From: edkcnw@comcast.net
Sent: Wednesday, March 24, 2021 12:51 PM
To: Tabitha Boschetti
Cc: Lindsey Hagerman; Steve Koper
Subject: RE: Public Comments- Notice ANN 20-0004- 23500 SW Boones Ferry Rd.

We appreciate the opportunity to provide Citizen Comments regarding the proposed ANN 20-0004 - Annexation of 23500 SW Boones Ferry Road by CPAH into the City of Tualatin.

LEA Comments
On the Draft Tualatin Stormwater Master Plan
(Dated April 2019)

Figure 11. County Existing Plan Drawings with Annotations Highlighting the ORIGINAL Conditions and Piping

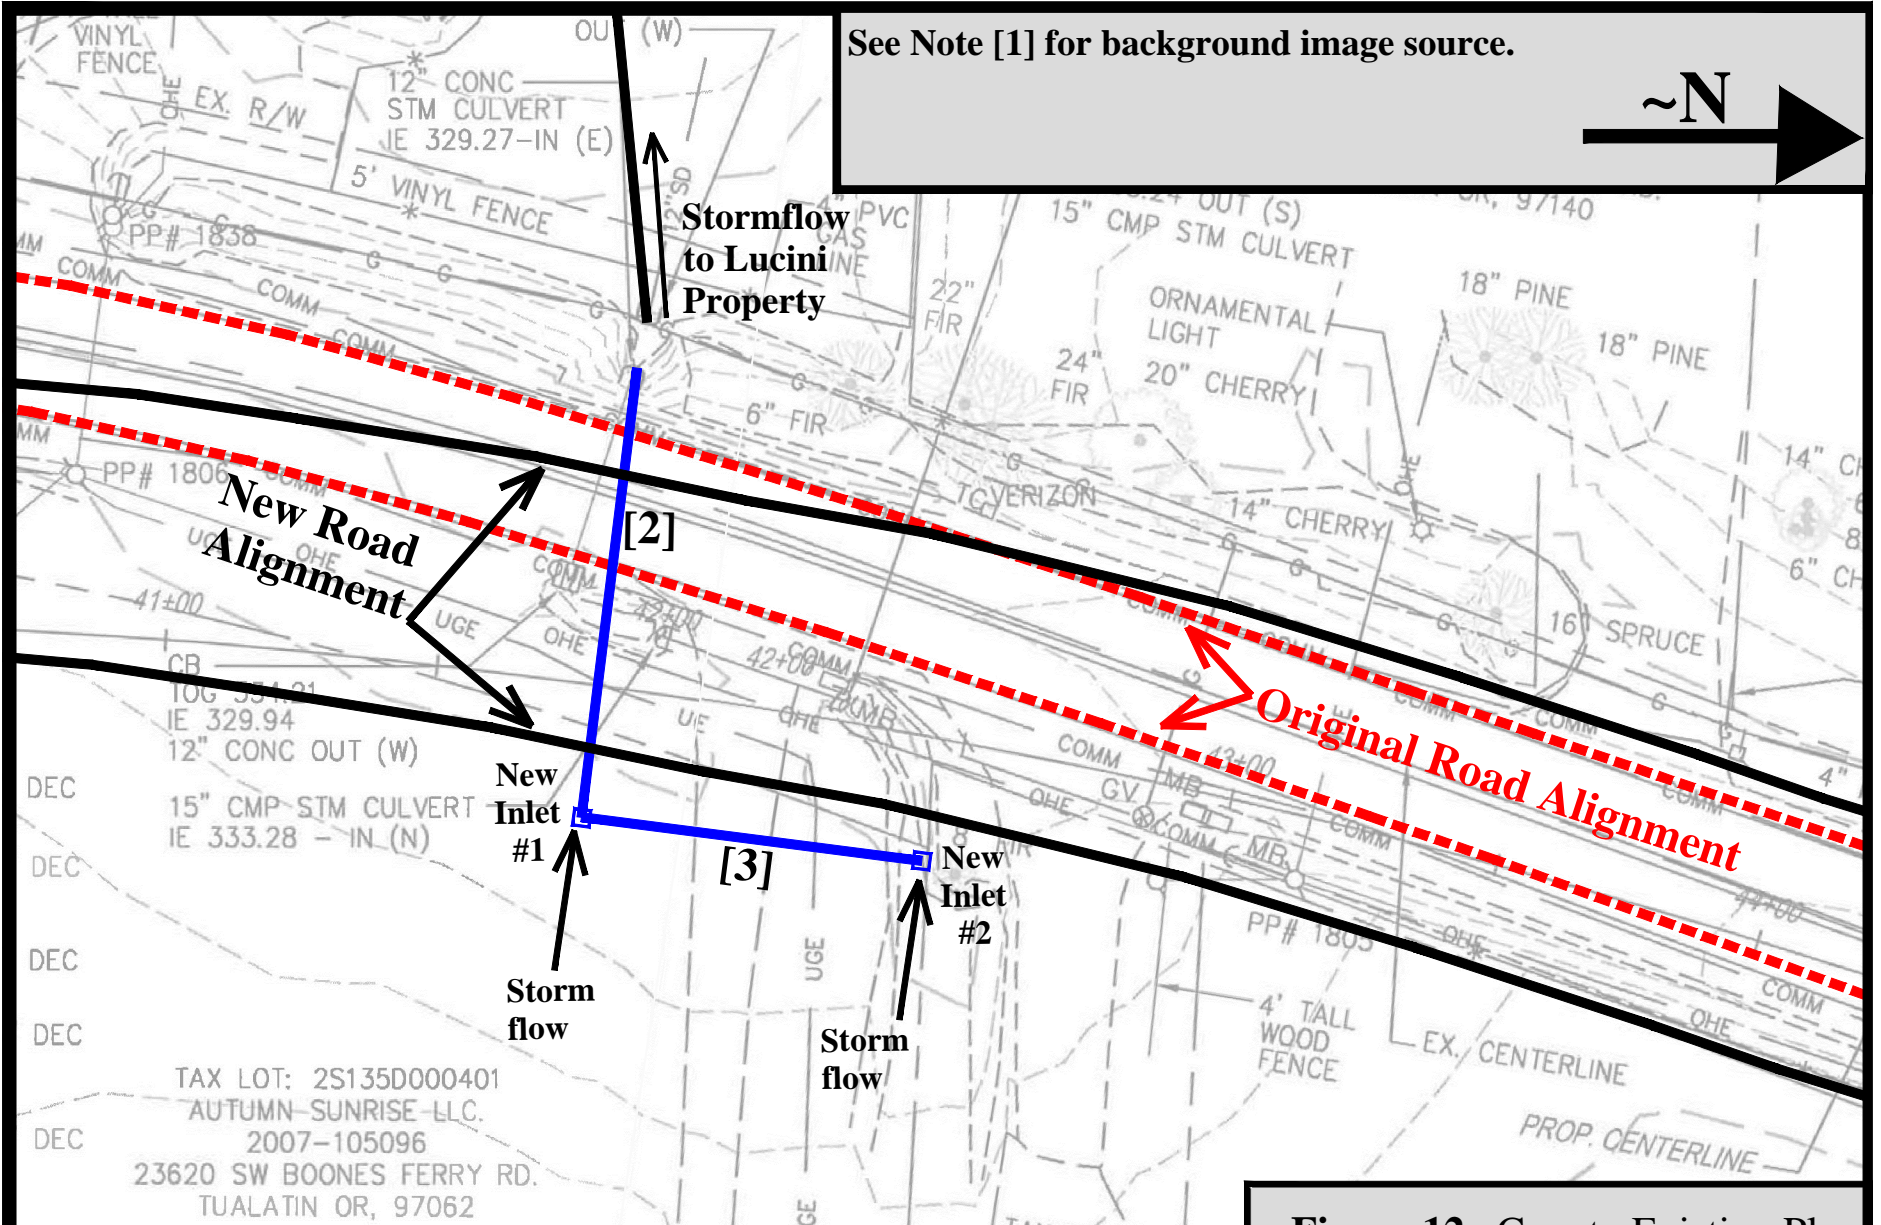
Figure 11 shows the hydraulic conditions for connecting piping and the original road culvert locations for the ORIGINAL configuration. Figure 12 illustrates the IMPLEMENTED hydraulic conditions consisting of connecting piping and the new culvert comprising the County's Outfall #5. Figure 12 also shows the juxtaposition of the old and new Boones Ferry Road that hydraulically affects flows to the Lucini property.

The County's Drainage Report says that the original road had curbs and storm sewers routing flows.²¹ This is incorrect as there were no curbs or storm sewers for SW Boones Ferry Road above the Lucini property. Drawings 2C-7 and 2C-8 excerpted in Appendix C demonstrate there were no curbs and storm sewers upstream of the Lucini property.²² Additionally, the photos in Appendix A1 taken by as part of the County's Wetland Delineation Report²³ and by the Lucini's also reveal the lack of curbs and storm sewers above the Lucini property. This is a crucial detail because it determines whether a portion of stormflows go south into the Greenhill Lane subbasin, or north into the subbasin above the Lucini property. In its Drainage Report the County erroneously claims that a portion of the Greenhill Lane subbasin stormwater drains into the Lucini property.

Figure 12. County Existing Plan Drawings with Annotations Highlighting the IMPLENTED Piping Conditions

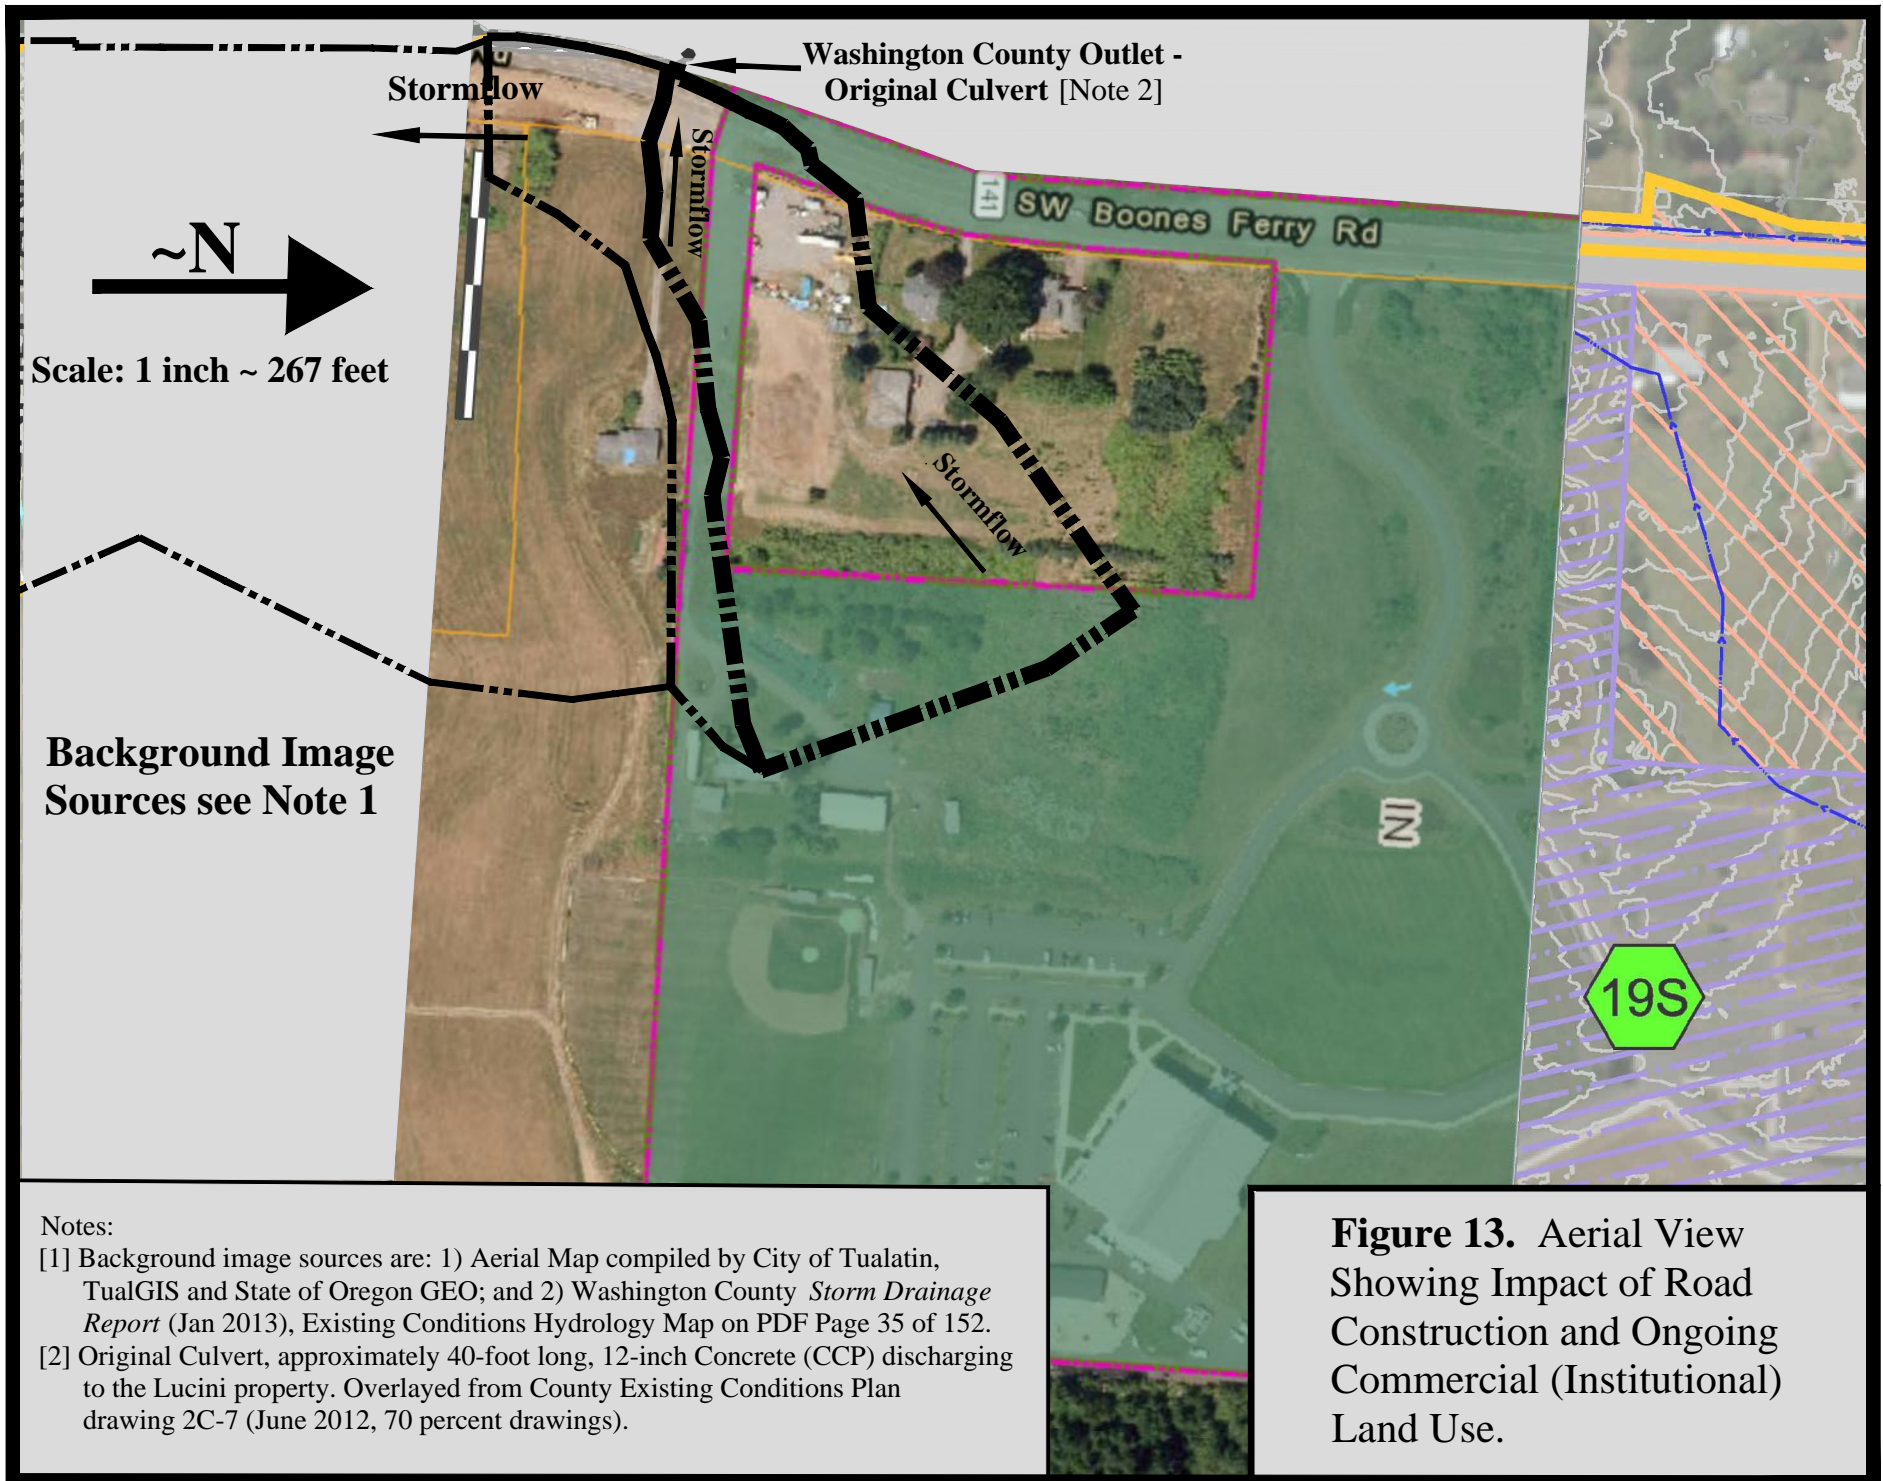
The County provided storm grates on its two new stormwater inlets in the subbasin above the Lucini property as shown in Figure 12. The County neglected to provide a storm grate for the pipe entrance to the Lucini property (see Figure 12). The Lucini property drainage receives stormwater passing through SW Boones Ferry Road culvert (Outfall #5). The County supposed that its generated stormflow will be conveyed successfully through the Lucini property. The Corps HEC-HMS and HEC-RAS demonstrate that this is not the case for the 25-year design storm cases presented in this analysis.

An orifice plate can be used to reduce storm pipe flow diameter and flow area during peak flow events. This physical measure decreases peak stormflows and lowers storm flow velocities on the Lucini property. The location of the proposed orifice plate is shown in Figure 12 as indicated in the IMPLEMENTED new storm inlet #1.

The County has indicated it is using CWS 2007 for guidance, which contains: Drawing No. 270 “Flow Control Structure Detail” that can be installed at the New Inlet #1 location; and Drawing No. 240 “Water Quality Manhole (Mechanical)” that can be installed just upstream of the Lucini property pipe entrance. For convenience, CWS Drawing Nos. 270 and 240 are contained in Appendix G of this report. See Figure 12 for the locations of these proposed flow and water quality control facilities.

Figure 13. Aerial View Showing Impact of Road Construction and Ongoing Commercial (Institutional) Land Use.

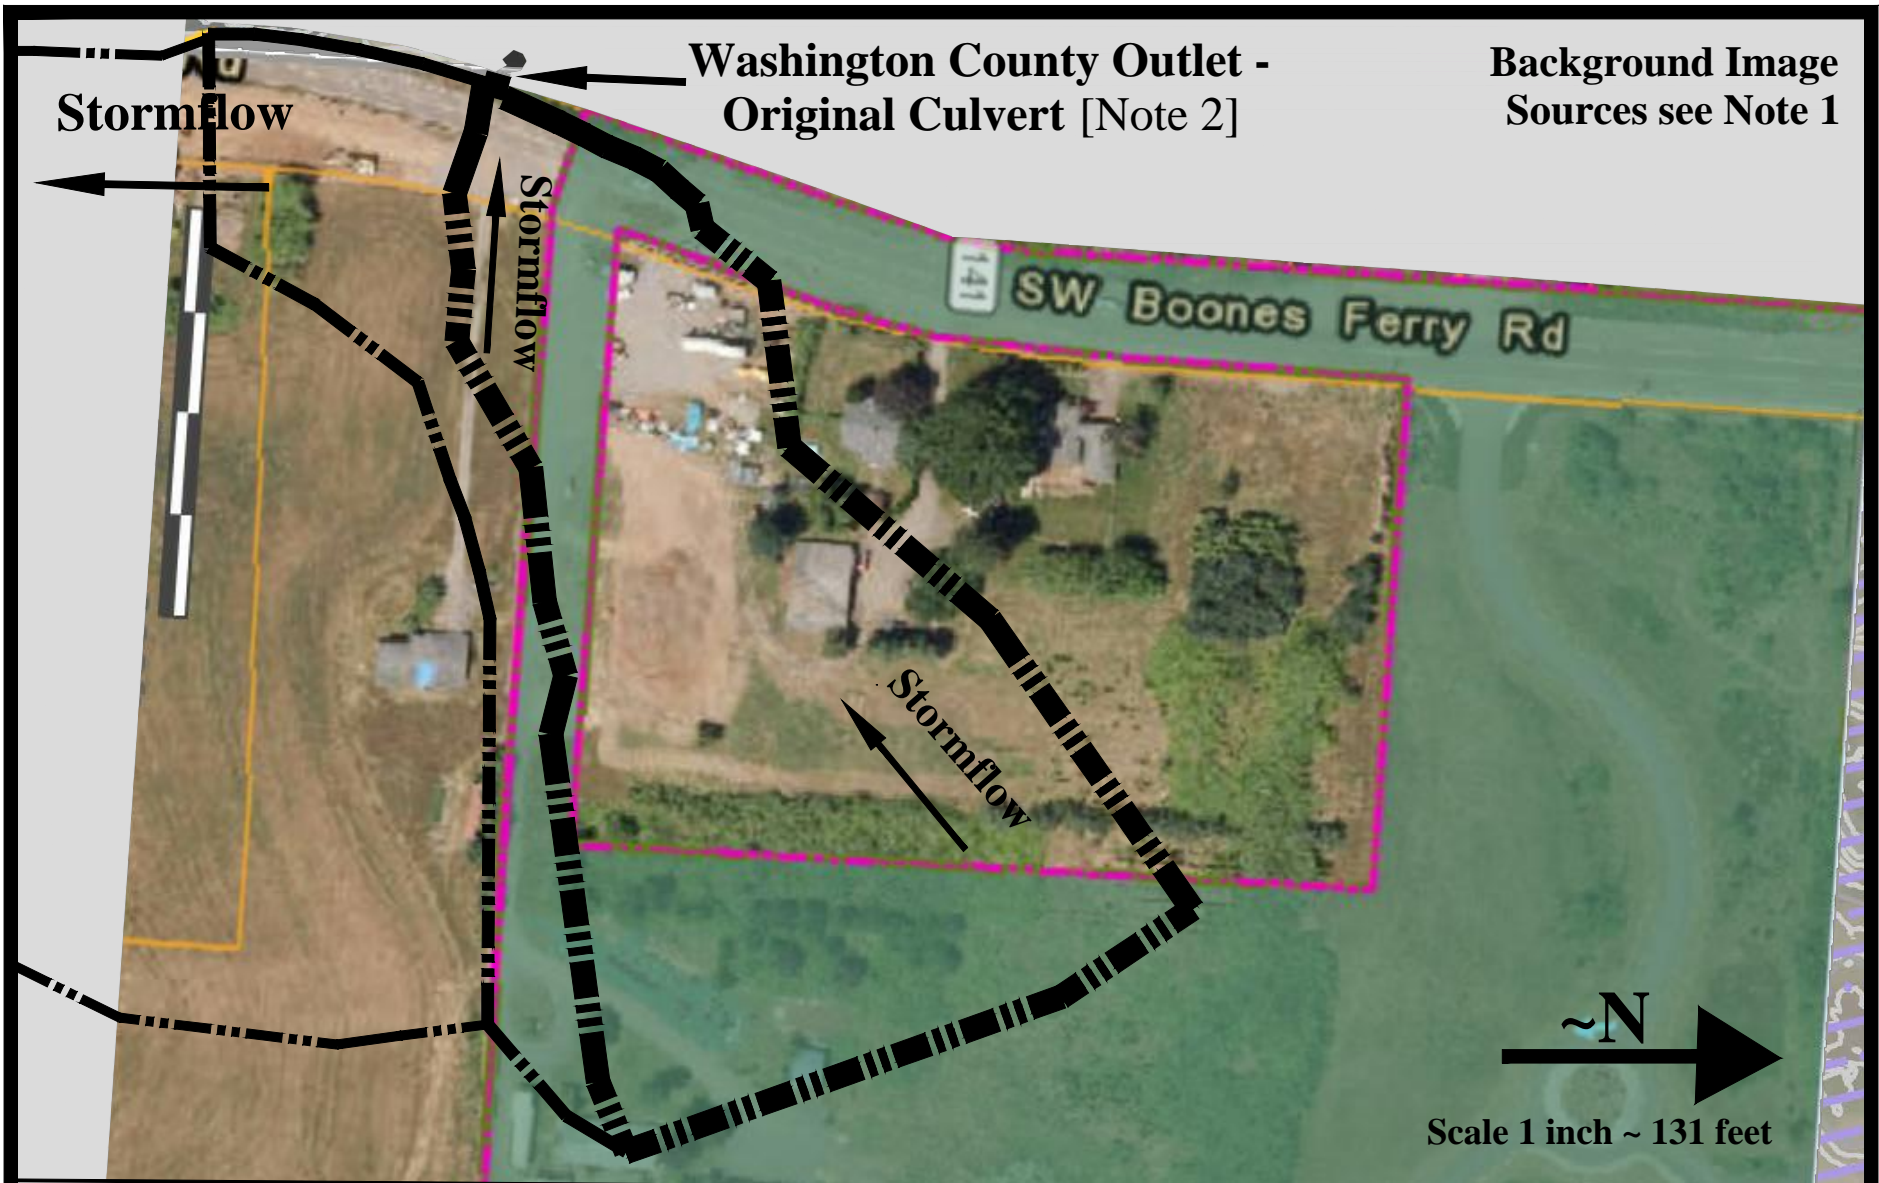
Ongoing land use considerations include road construction activities and large facility support conditions necessitated by the Horizon Community Church. These land use conditions can be seen in the aerial view presented in Figures 13 and 14. Appendix F also displays additional land use characteristics in the subbasin above the Lucini property. Road construction activities result in soil compaction from heavy equipment movement and parking as well as materials staging and other provisions necessitated by road construction. Figures 13 and 14 also show the sprawling Horizon Community Church complex that relies in part on the subbasin draining to the Lucini property. The church facilities include a driveway, service roads, vehicle parking, facility support buildings and other impervious features affecting runoff.

The County's Drainage Report disregarded construction development that increases runoff in the drainage upstream of the Lucini property. The County's hydrologic modeling of the upstream subbasin was characterized as "Farmstead" and single dwelling 2-acre lots. However, the actual additional use of a majority of the subbasin is to support heavy road construction and on-going use as commercial (Institutional), a more intense land-use from a stormwater generation standpoint. This relationship between the subbasin boundary delineation and active road construction (in 2012), equipment parking and material staging can be plainly seen in the aerial view presented in Figures 13 and 14.

Figure 15. HEC_RAS Hydraulic Profile of ORIGINAL Pipe and Ditch Conditions at 2.85 cfs Above and On the Lucini Property

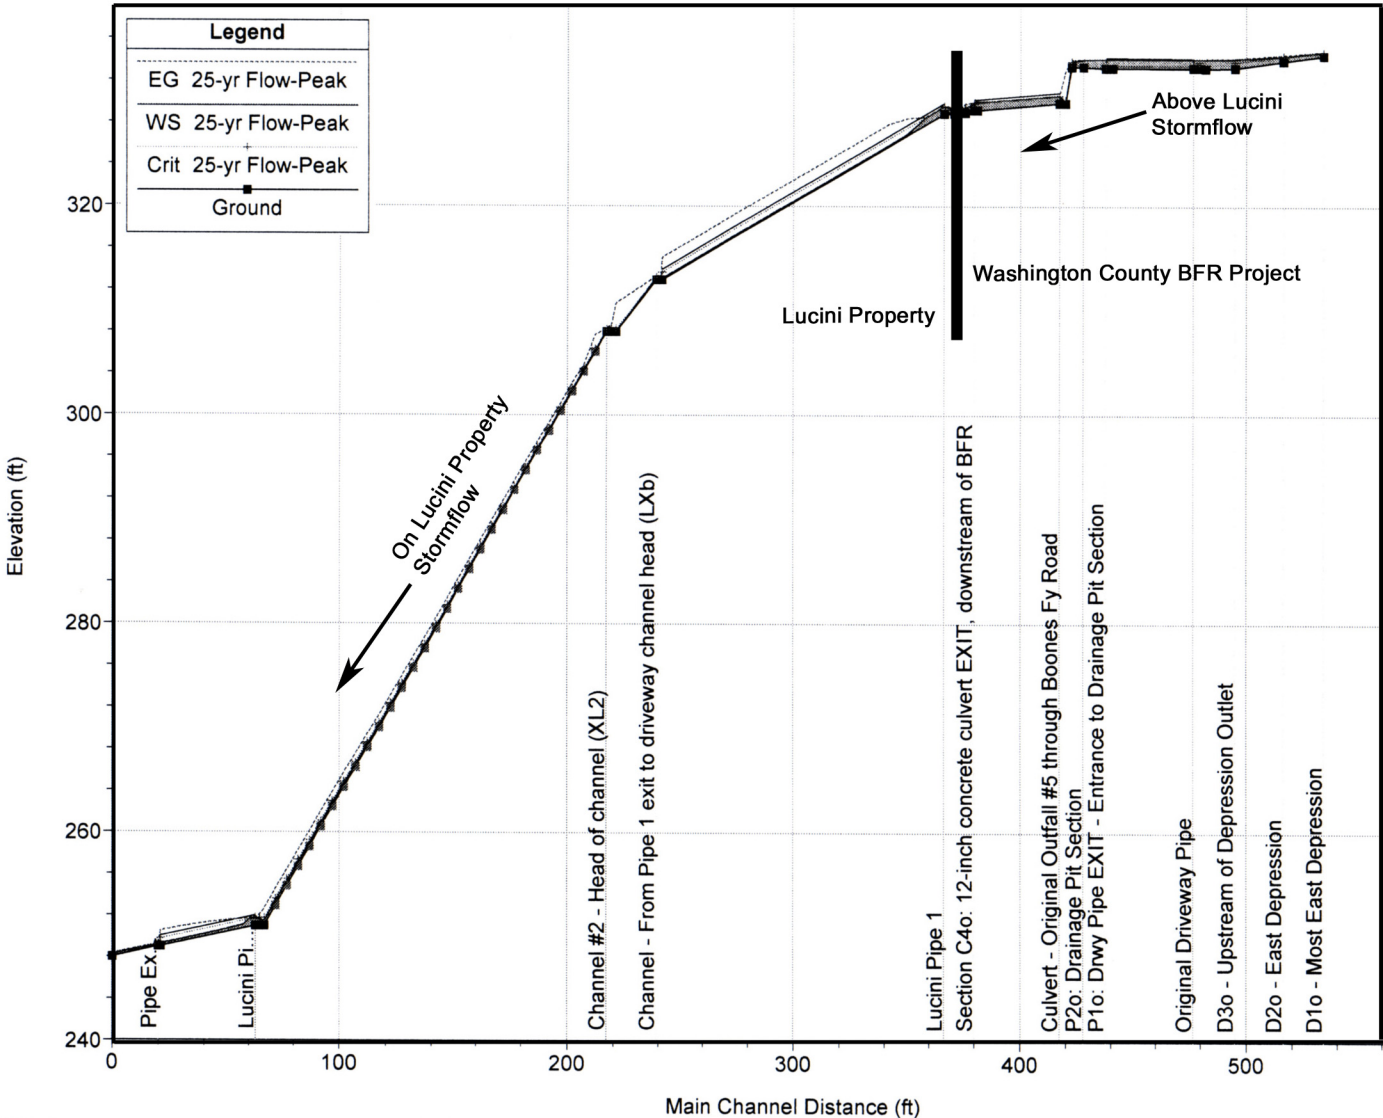
modeling assessing pipe and ditch flow conditions shows that excessive stormflow velocities are created on the steep slopes of the Lucini property. The estimated land profiles of the storm water conveyance is illustrated in Figure 15 and Appendix I).

Figure 15 depicts the hydraulic profile generated by HEC-RAS for the ORIGINAL configuration using runoff stormflows based on future full build-out development conditions at 2.85 cfs. Stormflow existing prior to the County's road project²⁶ (0.89 cfs) and additional profiles are also contained in Appendix I.
